MANDATORY SERVICE BULLETIN NO. MSB 40NG-070 REV. 0

Inspection of the safety ropes in the engine installation.

WORK INSTRUCTION WI-MSB 40NG-070 REV. 0

Figure 1. Locations of the safety ropes.

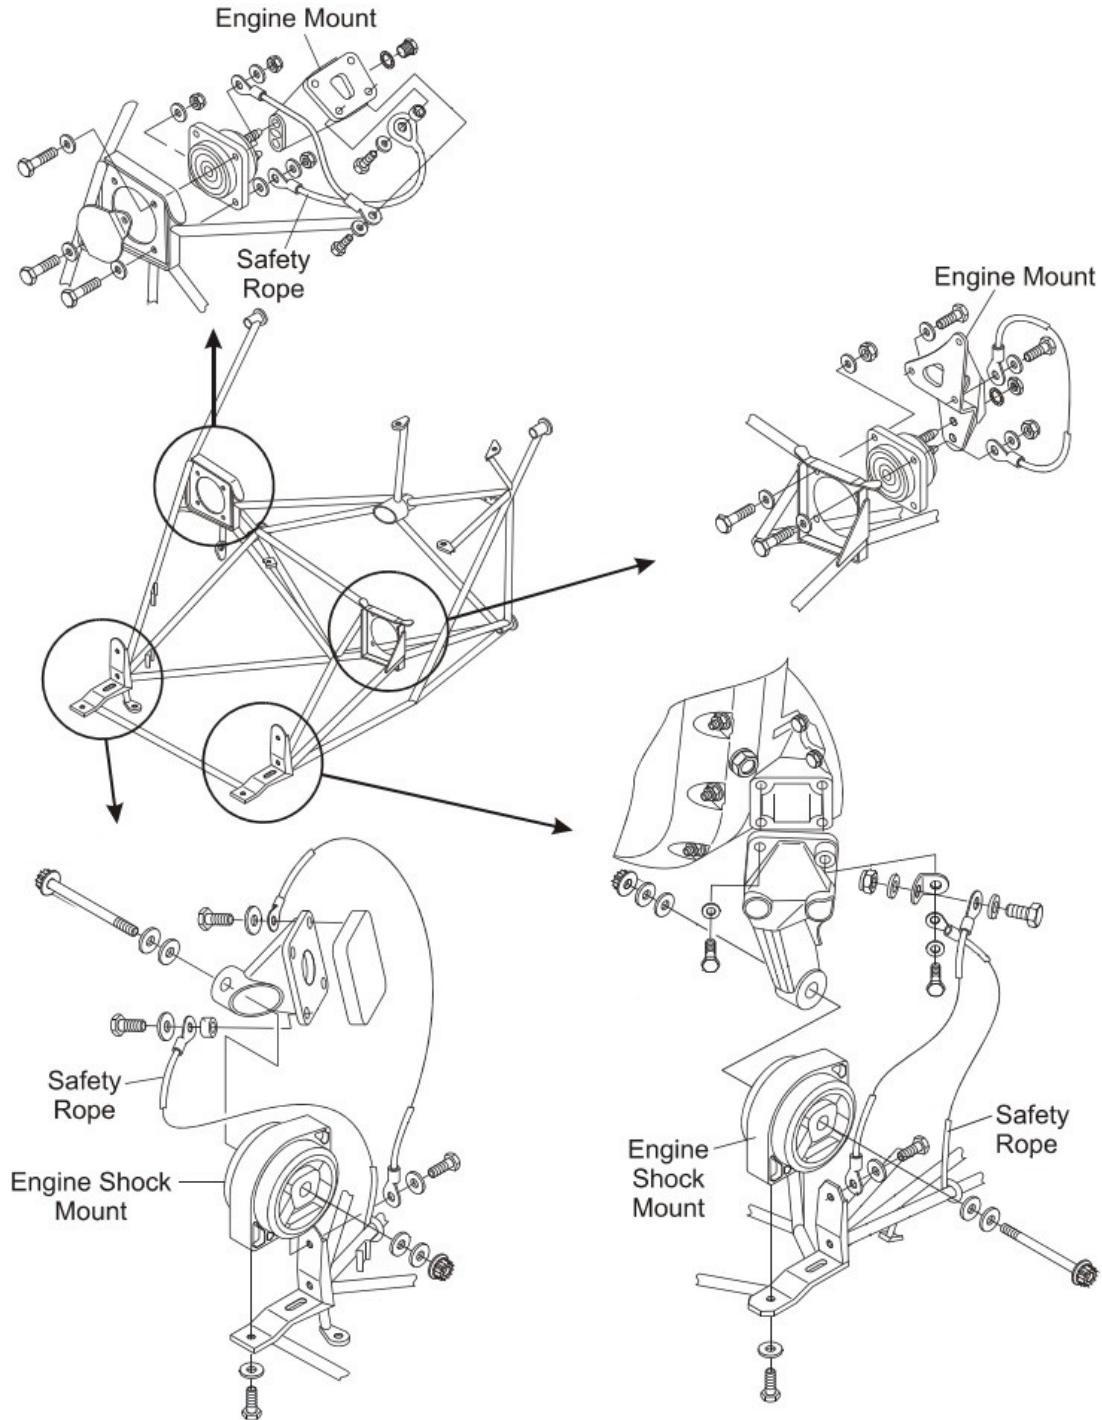
On some aircraft, the safety ropes in the engine installation have been observed to be chaffing against the engine mount or the oil pan, causing damage to these components. This MSB provides instructions for inspecting the engine installation for damage due to the safety ropes, and provides instructions to prevent the chaffing of the safety ropes against other components.

Figure 2. Safety rope at the front left of the engine. Note the silicone tape and zip tie used to secure the safety rope to the engine mount.

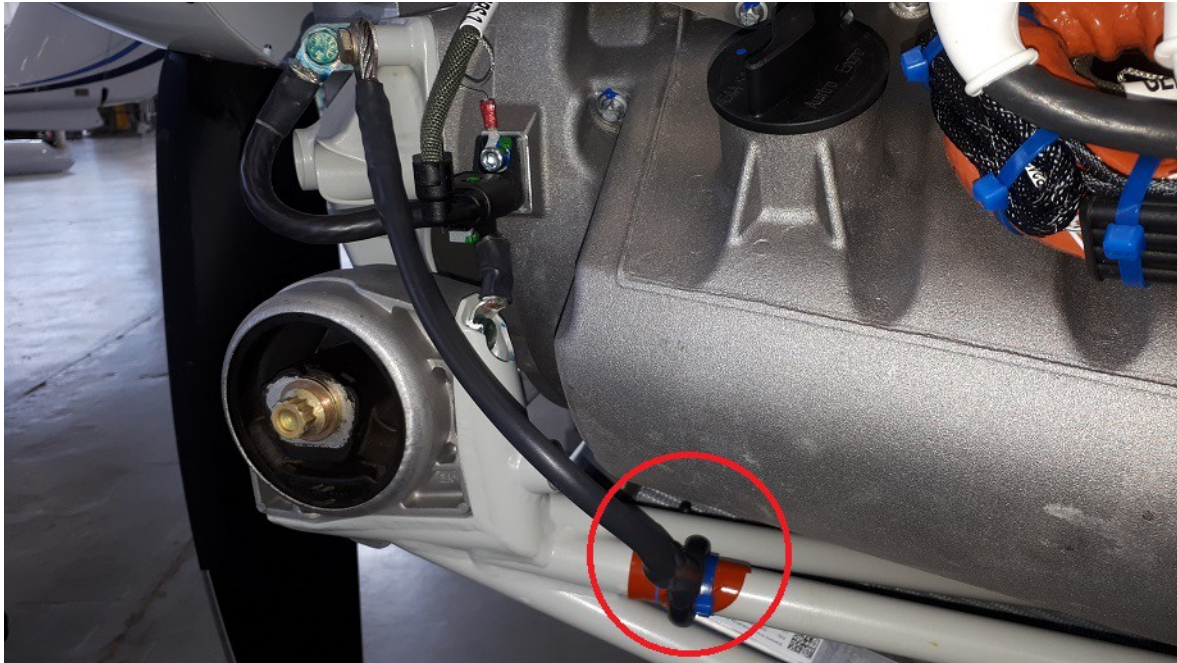
1. Ensure the engine is safe.
2. Remove the engine cowlings.
3. Inspect the safety rope and surrounding area at the front left of the engine (see Figure 2) for signs of chaffing. Pay special attention to the engine mount and the oil pan.

4. If the safety rope is not secured with silicone tape and a zip tie as shown in Figure 2, use silicone tape and a zip tie to secure the safety rope.
 - A. Ensure the safety rope is as far forward as possible, and does not interfere with other components in the engine installation or the cowling when installed.
 - B. Ensure the silicone tape completely wraps twice around the tube of the engine mount.
